FINAL VALIDATION REPORT

BWC Sustainable Biogas Recovery Programme
of Activities in Indonesia

Report No. 01 997 9105070303-1/2

Version No. 1.1, 10-12-2012

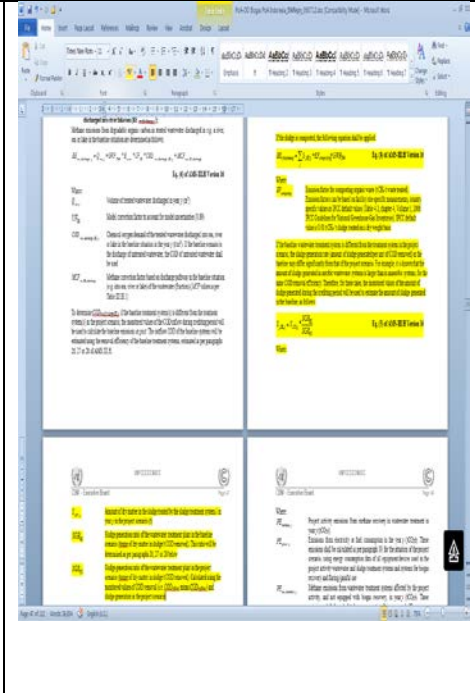
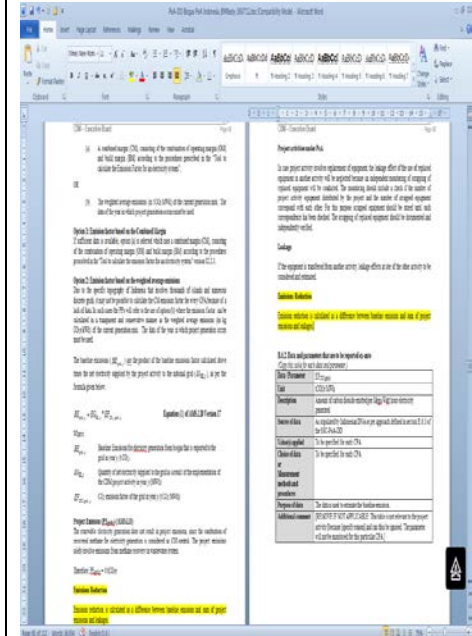
<p>3.2) Figure II.B.3.1 & Figure II.B.3.2 Flow diagram as shown in the Generic CPA are not yet fully shown the physically delineating each generic CPAs, based on the descriptions provided in section A.6 “Technologies/measures” of Part I above, as prescribed in the Guidelines for Completing the Programme Design Document Form for Small- Scale CDM Programme of Activities, EB 66, Annex 13, Version 01.0</p>	B.3	<p>Response No. 1 Flow diagram Figure II.B.3.1 & Figure II.B.3.2 are generic in nature but each CPA-DD is required to delineate the project boundary in a flow diagram in accordance with the completing guideline of the CPA-DD.</p>	B.3	<p>Response No. 1 OK, the revised diagram are accepted by the validation team</p> <p>CAR-g3.2 is resolved & closed</p>
	<p>3.3) Figure II.B.3.1 & Figure II.B.3.2 Flow diagram has not yet includes all of the equipment, systems and flows of mass and energy described in that section A.6, as prescribed in the Guidelines for Completing the Programme Design Document Form for Small- Scale CDM Programme of Activities, EB 66, Annex 13, Version 01.0</p>	B.3	<p>Response No. 1 Flow diagram Figure II.B.3.1 & Figure II.B.3.2 is generic in nature but each CPA-DD is required to delineate the project boundary in a flow diagram in accordance with the completing guideline of the CPA-DD.</p> <p>Response No. 2: The mill/factory is not indicated in the diagram because it would typically not be affected by the project activity. Sludge disposal is now also indicated in the figure. Downstream facilities may vary per CPA and hence will be indicated at CPA level.</p>	B.3	<p>Response No. 1 OK, the equipment such as digester / generators / flaring system / transformer have been defined clearly including the flows in the flow diagram</p> <p>What about the other items such as mill / factory? End sludge application? Any downstream facilities identified in the project boundary?</p> <p>Response No. 2 OK, this is accepted by the validation team since this is in line with the project boundary descriptions in AMS-I.D & AMS-III.H methodology requirements</p> <p>CAR-g3.3 is resolved & closed</p>

<p>3.4) Figure II.B.3.1 & Figure II.B.3.2 The diagram has not indicated the emissions sources and GHGs included in the project boundary and the data and parameters to be monitored, as prescribed in the Guidelines for Completing the Programme Design Document Form for Small- Scale CDM Programme of Activities, EB 66, Annex 13, Version 01.0</p>	B.3	<p>Response No. 1 Flow diagram Figure II.B.3.1 & Figure II.B.3.2 is generic in nature but each CPA-DD is required to delineate the project boundary in a flow diagram in accordance with the completing guideline of the CPA-DD.</p> <p>Response No. 2 The GHGs + data & parameters to be monitored are now indicated, but of indicative nature. The complete monitoring plan in accordance with the methodology will be described in the diagram of each CPA.</p>	B.3	<p>Response No. 1 3.1.2) However, the Guidelines For Completing The Programme Design Document Form For Small Scale CDM Programme of Activities, Version 02.0, EB 67, Annex 30, page 8 stated that “.....<i>Include in the flow diagram all the equipment, systems and flows of mass and energy described in that section. In particular, indicate in the diagram the emissions sources and GHGs included in the project boundary and the data and parameters to be monitored</i>”</p> <p>Figure II.B.3.2 Flow diagram of the project boundary for technological scenario 1 and two in combination with scenario E - not yet included the emission sources & GHGs + data & parameters to be monitored</p> <p>Response No. 2 However, although the GHGs + data & parameters to be monitored are indicated as of indicative nature, but this is not in line with the guideline requirement & not traceable to the specific parameters to be monitored at specific CPA level. “Indicative nature” can be accepted as long some means of</p>

<p>Response No. 3 The diagram has been revised to show the GHGs + data & parameters to be monitored for a typical CPA under the PoA. Please refer to Figure II.B.3.1 & Figure II.B.3.2.</p> <p>Response No. 4 Figure II.B.3.1 and Figure II.B.3.2 have been revised to indicate parameter COD_{ww, discharge, y}. $FC_{DIESEL,j,y}$; $FC_{FO,j,y}$; $FC_{COAL,j,y}$ $NCV_{DIESEL,y}$; $NCV_{FO,y}$; $NCV_{COAL,y}$ $EF_{CO2,DIESEL,y}$; $EF_{CO2,FO,y}$; $EF_{CO2,COAL,y}$</p> <p>Furthermore, Parameter $n_{flare, h}$ is now indicated in Generic CPA-DD Section B.7.1 and Figure II.B.3.1 and Figure II.B.3.2. Duplicate parameter FE (flare efficiency) has been removed from the figures.</p>	<p>traceability to specific monitoring parameters are made available at Generic CPA – DD For “the emissions sources and GHGs”, GHGs have been indicated in the diagram but not linked to its sources?</p> <p>Response No. 3 The revised diagram is accepted by the validation team The diagram will be checked again once all CAR / CL related to monitoring parameters are closed</p> <p>Response No. 4 Figure II.B.3.1 Parameter COD_{ww, discharge, y} is missing</p> <p>Figure II.B.3.2 Parameters as follows are missing – please re-confirm $COD_{ww, discharge, y}$ $FC_{DIESEL,j,y}$; $FC_{FO,j,y}$; $FC_{COAL,j,y}$ $NCV_{DIESEL,y}$; $NCV_{FO,y}$; $NCV_{COAL,y}$ $EF_{CO2,DIESEL,y}$; $EF_{CO2,FO,y}$; $EF_{CO2,COAL,y}$</p> <p>Parameter $n_{flare, h}$ is included in Figure II.B.3.2 but missing in Generic CPA-DD Section B.7.1?</p> <p>Response No. 5 3.4) OK this has been corrected</p>
